DS2155

T1/E1/J1 Single-Chip Transceiver

REVISION A3 ERRATA

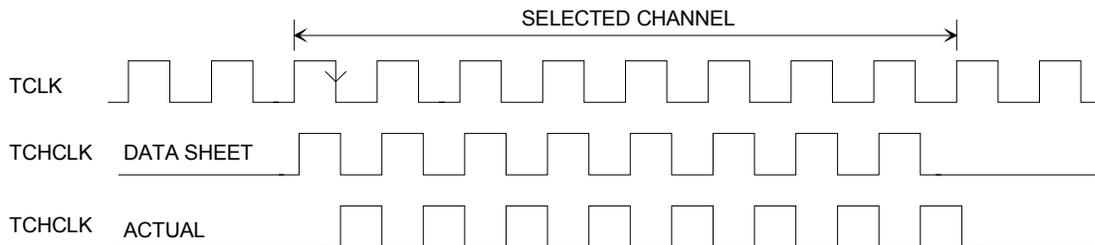
The transmit fractional support (alternate function of the TCHCLK pin) does not operate as described in the data sheet. Transmit data at the TSER pin is sampled on the falling edge of TCLK. In fractional support mode the TCHCLK pin should output a clock (gated version of TCLK) during a selected channel or channels. The rising edge of this clock could be used to present data to the TSER pin for sampling in the falling edge of TCLK. However, TCHCLK is delayed one-half clock in this rev of the DS2155. Its rising edge occurs AFTER the sampling time of the corresponding bit time of TCLK, as shown below.

There is no known software work around for this issue.

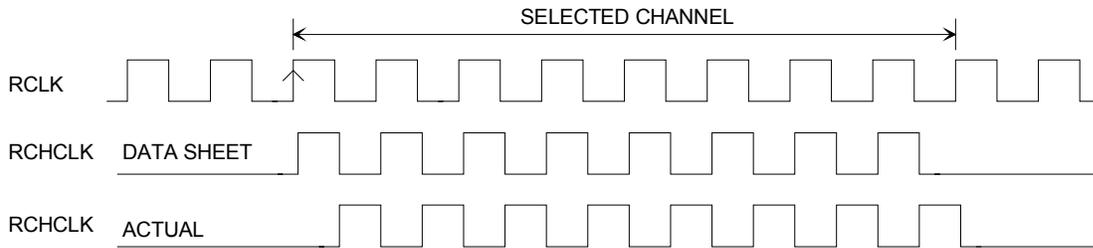
The receive fractional support (alternate function of the RCHCLK pin) does not operate as described in the data sheet. Receive data at the RSER pin is updated on the rising edge of RCLK. In fractional support mode the RCHCLK pin should output a clock (gated version of RCLK) during a selected channel or channels. The falling edge of this clock could be used by the backplane to sample data output on the RSER pin. However, RCHCLK is delayed one half clock in this rev of the DS2155.

As an alternate method, the backplane can use the rising edge RCHCLK to sample data output from RSER.
